STAFF RECOMMENDATION 4914 Tanglewood Drive May 17, 2017

Application: New construction –infill
District: Tanglewood Historic Preservation Zoning Overlay
Council District: 04
Map and Parcel Number: 06104003400
Applicant: Cheyenne Smith
Project Lead: Melissa Baldock, melissa.baldock@nashville.com

Description of Project: Application is to construct infill on a vacant lot.

Figure 1. The house formerly on the lot that burned in January 2017.

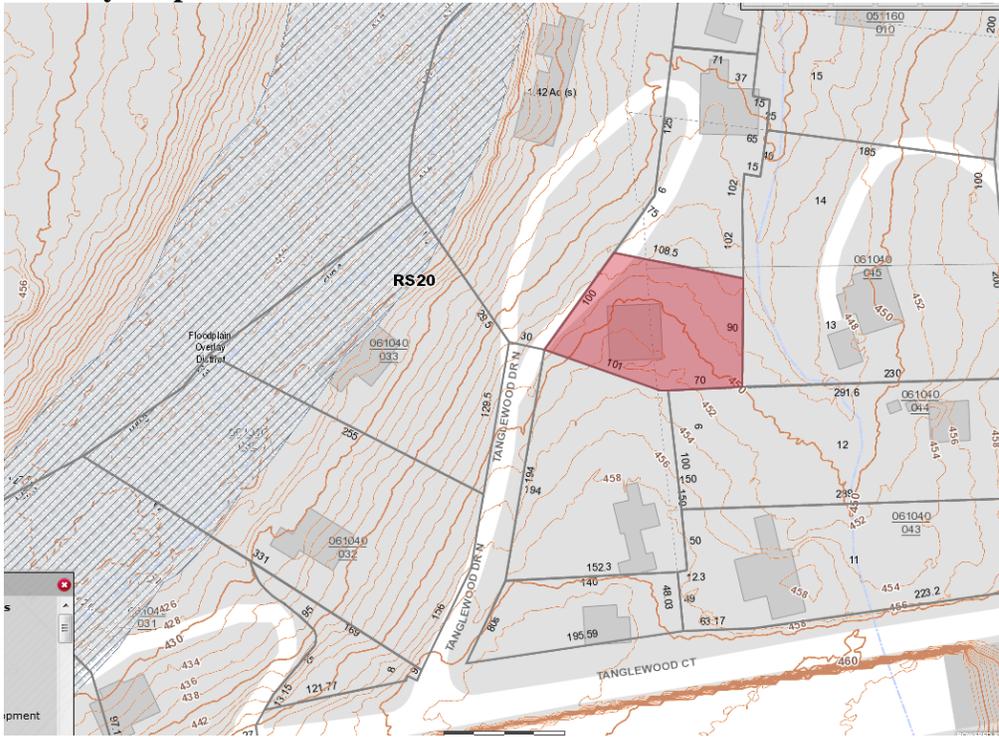
Background: 4914 Tanglewood Drive is currently a vacant lot (Figure 1). The house formerly on the lot burned to the ground in January 2017 (Figure 2). It was the Llewellyn House (Gatehouse), constructed at the edge of the National Register (1998) boundaries. It was originally a combination barn and shed constructed in 1927 and later converted into a dwelling. It had a large two-story weatherboard frame addition on the north side. Do to alterations in 1947 and 1980, the National Register Nomination lists it as non-contributing.

Figure 3: Property shown in relationship to the overall district.

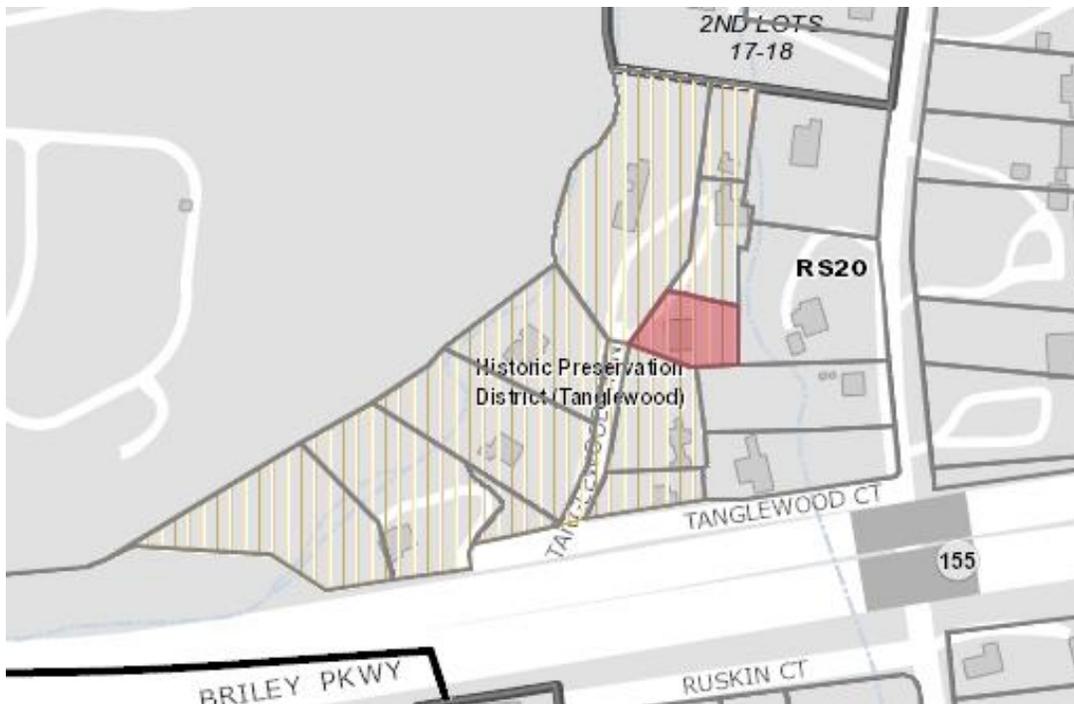
Setback and Rhythm of Spacing: The proposed infill will meet all base zoning setbacks. It will be located in the approximate location of previous house on the lot. The surrounding context has large, wooded lots, with varying locations for the houses. The new infill therefore will not disrupt the established front setbacks and rhythm of spacing of the district. Staff finds that the infill's setback and rhythm of spacing meet Section III.A.2.a. of the design guidelines.

01 FRONT ELEVATION (WEST)

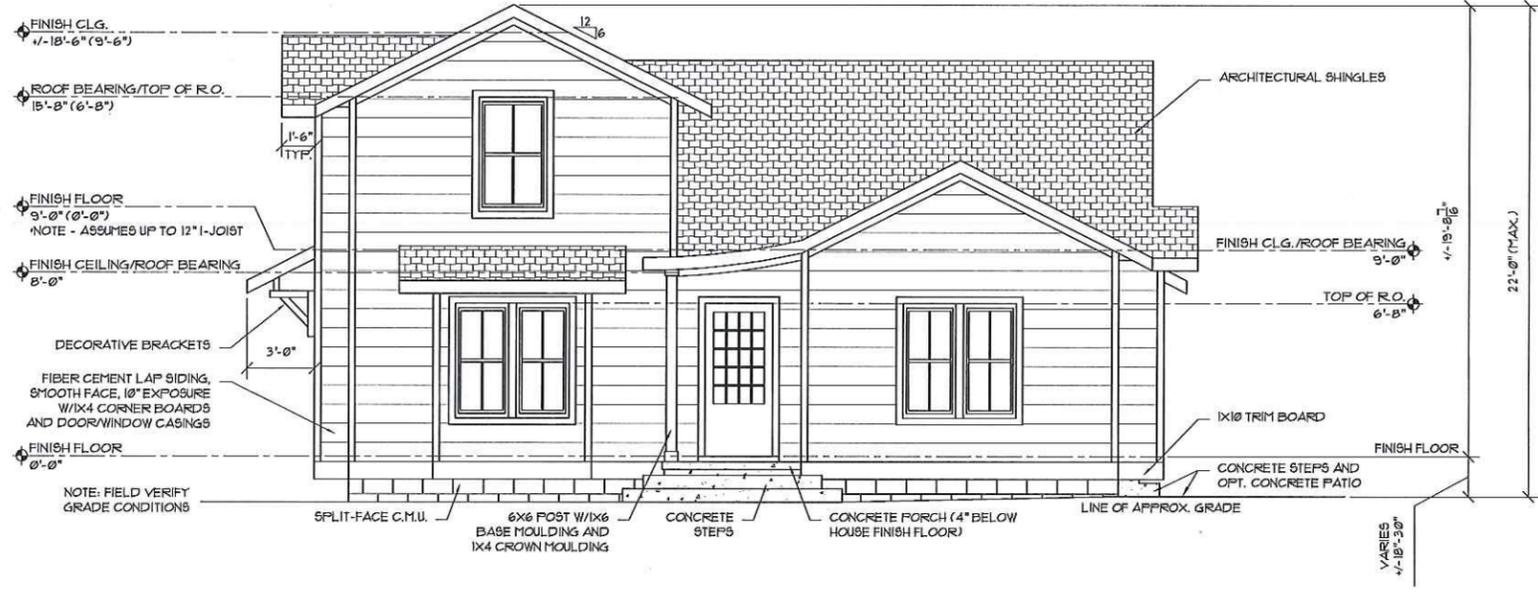
Height and Form. The proposed infill will be largely one-and-a-half stories with a two story bay at the front and on the rear. The bulk of the house will be twenty feet (20') tall, which matches the height of the house previously on the site. The two story bay on the left side of the house will have a height of twenty-two feet (22'), which staff finds to be appropriate. The former house on the lot also had a two-story extension and portions of other buildings in the district read as two-stories due to changes in grade. Staff recommends that the finished floor height be consistent with the finished floor heights of the adjacent historic houses, to be verified by MHZC staff in the field

Roof Form: The primary roof form will have a side gable form with a slope of 6/12. The gabled bays will also have slopes of 6/12. Staff finds that the proposed roof form is compatible with the surrounding historic context and meets Section III.A.2.d. of the design guidelines.

Proportion and Rhythm of Openings: The windows on the proposed infill are all generally twice as tall as they are wide, thereby meeting the historic proportions of openings. There are no large expanses of wall space without a window or door opening. Staff finds the project's proportion and rhythm of openings meet Section III.A.2.f. of the design guidelines.

*The applicant is proposing siding that has a reveal of ten inches (10"). MHZC usually requires that siding have a maximum reveal of five inches (5"), as historically, siding was not typically wider than five inches (5"). However, staff finds the ten inch (10") siding to be appropriate for this infill for several reasons. In the Tanglewood Historic Preservation Zoning Overlay, the buildings are predominantly log homes. The logs tend to be wider than five inches (5"). In addition, the house previously on the lot had siding that was ten inches (10"). Narrow siding is not a common feature of this cohesive district.

1. The finished floor height be consistent with the finished floor heights of the adjacent historic houses, to be verified by MHZC staff in the field;
2. Staff approve the final details, dimensions and materials of windows and doors prior to purchase and installation;
3. Staff approve the roof color;
4. Staff approve the material of the driveway and parking area;
5. The HVAC shall be located behind the house or on either side, beyond the mid-point of the house; and
6. Staff approve all permanent landscape features, including, but not limited to, pathways, fencing, etc.

02 SITE PLAN

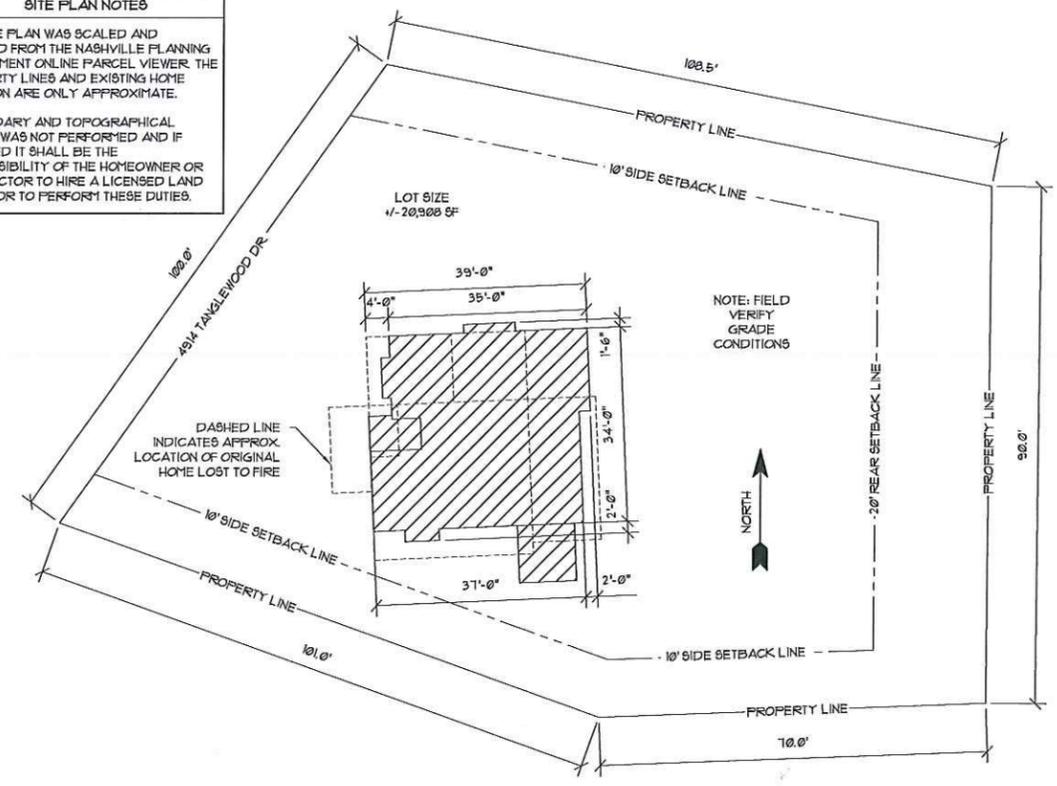
Orientation: The house is oriented to face Tanglewood Drive, which is appropriate. The primary entrance will be behind a covered stoop that is nine feet (9') deep. Vehicular access to the site will be from a front driveway and will match what was there for the previous house (see Figure 2). Walkways leading to the street are not a typical feature of this neighborhood, and therefore one is not required here. Staff finds that the proposed orientation meets Section III.A.2.e. of the design guidelines.

Appurtenances & Utilities: No changes to the site's appurtenances were indicated on the site plans. Staff recommends that the HVAC and other utilities be located at the rear of the infill, or on a side façade beyond the midpoint of the house. In addition, staff recommends that the applicant return to MHZC staff for approval of all other appurtenances, including fencing, pathways, and all permanent landscape features.
